# Access Compliance Report

## Public Rights-of-Way

Intersection ID: 11898	Main Street: ALLEN_ST	Cross Street: E_18TH_ST	Location: E
ADA ID: 8D7244D3CD35	Ramp Type: PerpDiag	Initial Pass/Fail: Fail	Overall Compliance: No
Severity Score: 1.25			
Codes/Mitigation Info/Possible Solution		Field Measurements/Component Compliance

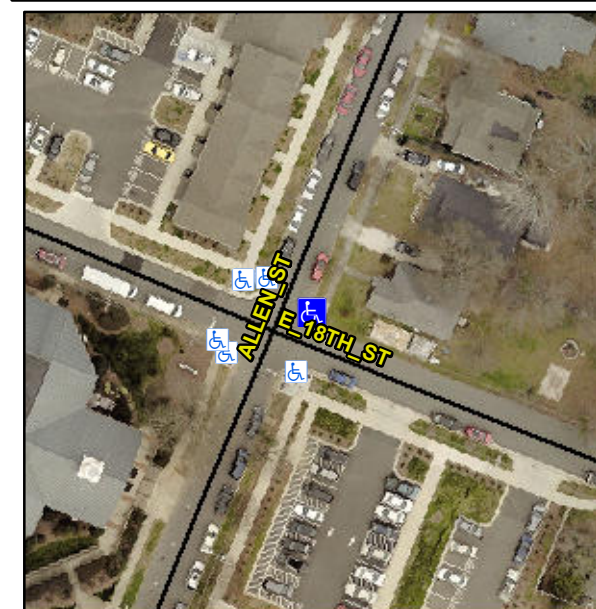
**R304.5.3**

Compliance	Description	Data	Compliance	Description	Data
N/A	Ramp Length (in)	81.0	Yes	Ramp Slope (%)	5.4
Yes	Ramp Width (in)	55.0	No	Ramp XSlope (%)	2.3
N/A	Flare Type LT	N/A	N/A	Flare Type RT	N/A
N/A	Flare Slope LT (%)	N/A	N/A	Flare Slope RT (%)	N/A
N/A	Flare Traversable LT?	N/A	N/A	Flare Traversable RT?	N/A
N/A	Landing Length (in)	N/A	N/A	DWS Provided?	N/A
N/A	Landing Width (in)	N/A	N/A	DWS Contrast?	N/A
N/A	Landing Slope (%)	N/A	N/A	DWS Length (in)	N/A
N/A	Landing X Slope (%)	N/A	N/A	DWS Full Width?	N/A
N/A	Landing Curb? (Y/N)	N/A	N/A	DWS Offset (in)	N/A
N/A	Shared Landing?	N/A			
N/A	Gutter Ponding?	N/A	N/A	Gutter Slope (%)	N/A
N/A	Gutter Lip Ht (in)	N/A	N/A	Gutter X Slope (%)	N/A
N/A	Painted X Walk1?	No	N/A	Painted X Walk2?	No
	X Walk 1 Direction	To NW		X Walk 2 Direction	To SW
N/A	X Walk 1 Width (in)	N/A	N/A	X Walk 2 Width (in)	N/A
	X Walk 1 Slope (%)	5.8		X Walk 2 Slope (%)	0.6
	X Walk 1 X Slope (%)	0.1		X Walk 2 X Slope (%)	2.3

**Remove & Replace Curb Ramp With Two New Directional Ramps or Equivalent.**
